Intersection ID: 10016063	Main Street: N_TRYON_ST	Cross Street: N/A	Location:	SW
ADA ID: 433A32CFC267	Ramp Type: PerpDiag	Initial Pass/Fail: Fail	Overall Compliance: No	Severity Score: 12.5

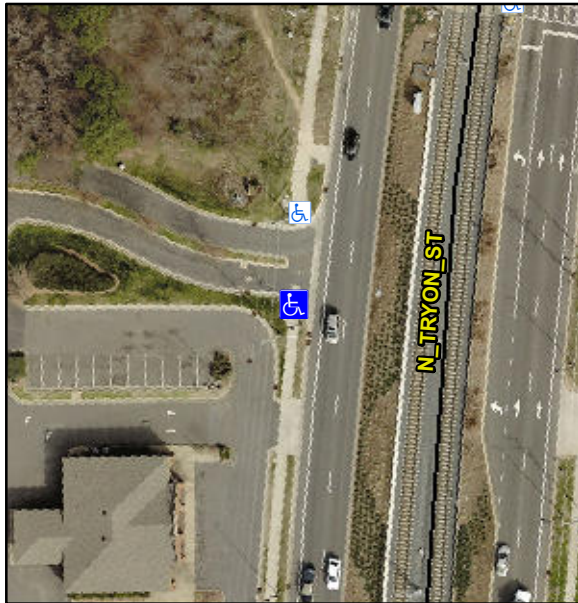
R304.5.3

Compliance	Description	Data	Compliance	Description	Data
N/A	Ramp Length (in)	46.0	Yes	Ramp Slope (%)	6.6
Yes	Ramp Width (in)	48.0	No	Ramp XSlope (%)	6.1
N/A	Flare Type LT	N/A	N/A	Flare Type RT	N/A
N/A	Flare Slope LT (%)	N/A	N/A	Flare Slope RT (%)	N/A
N/A	Flare Traversable LT?	N/A	N/A	Flare Traversable RT?	N/A
N/A	Landing Length (in)	N/A	N/A	DWS Provided?	N/A
N/A	Landing Width (in)	N/A	N/A	DWS Contrast?	N/A
N/A	Landing Slope (%)	N/A	N/A	DWS Length (in)	N/A
N/A	Landing X Slope (%)	N/A	N/A	DWS Full Width?	N/A
N/A	Landing Curb? (Y/N)	N/A	N/A	DWS Offset (in)	N/A
N/A	Shared Landing?	N/A			
N/A	Gutter Ponding?	N/A	N/A	Gutter Slope (%)	N/A
N/A	Gutter Lip Ht (in)	N/A	N/A	Gutter X Slope (%)	N/A
N/A	Painted X Walk1?	No	N/A	Painted X Walk2?	No
	X Walk 1 Direction	To E		X Walk 2 Direction	To N
N/A	X Walk 1 Width (in)	N/A	N/A	X Walk 2 Width (in)	N/A
	X Walk 1 Slope (%)	1.4		X Walk 2 Slope (%)	2.6
	X Walk 1 X Slope (%)	1.6		X Walk 2 X Slope (%)	1.4

Remove & Replace Curb Ramp With Two New Directional Ramps or Equivalent.
